Expert Witness Statement of Robert Campbell Swan - Drainage

Amendment C395 Geelong Planning
Scheme

AWE200050

6 November 2019

Figure 8-1 Indicative Creek Cross Section (taken from the Cowies Creek Corridor)

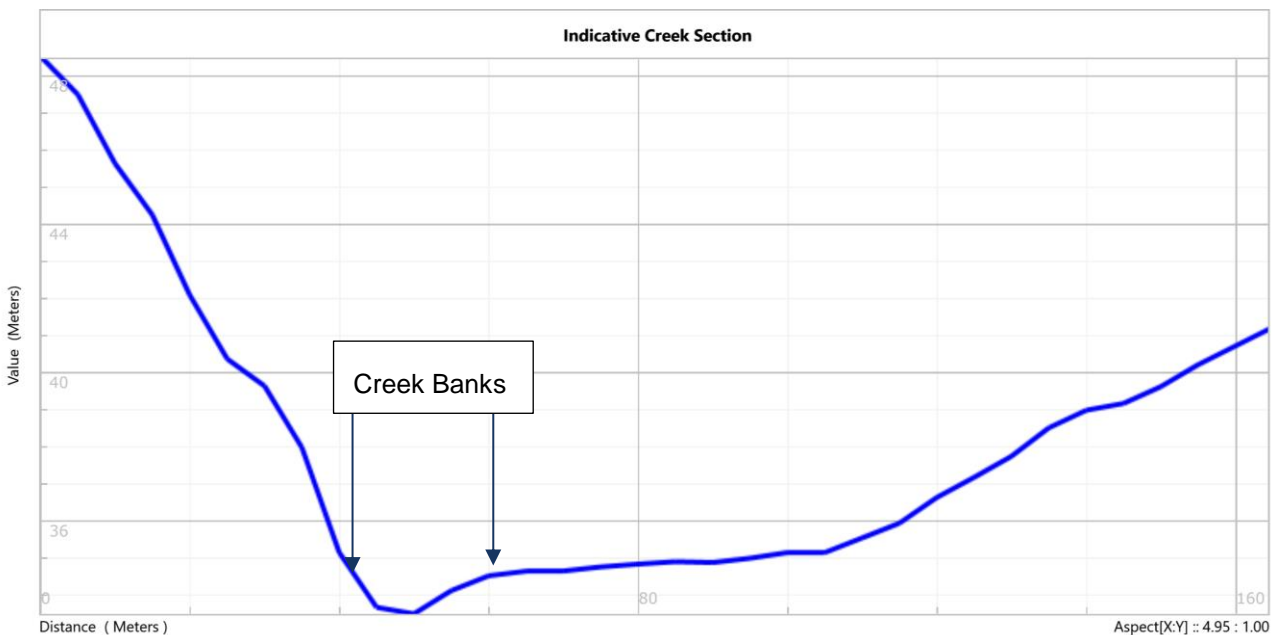
I note that in the Waterway Corridor Guidelines, the extent of offsets and setbacks can be varied to account for site specific conditions. This can involve a narrowing of the corridor widths, particularly if the natural landform does not require such wide buffers. There are a number of cases where a smaller buffer may be appropriate, including:

- > a heavily incised creek, where the 1% AEP flood extent is contained within the incised valley.
- > A waterway where the floodplain is not generally symmetrical as shown in Figure 8-1. In this example section, taken from the Cowies Creek corridor, a 50m buffer either side of the creek bank would not cover the main floodplain features on the right hand side of the creek, and would include areas on the left of the creek that do not significantly contribute to waterway health. In this case, a smaller buffer on the left and a wider buffer on the right would be justified.
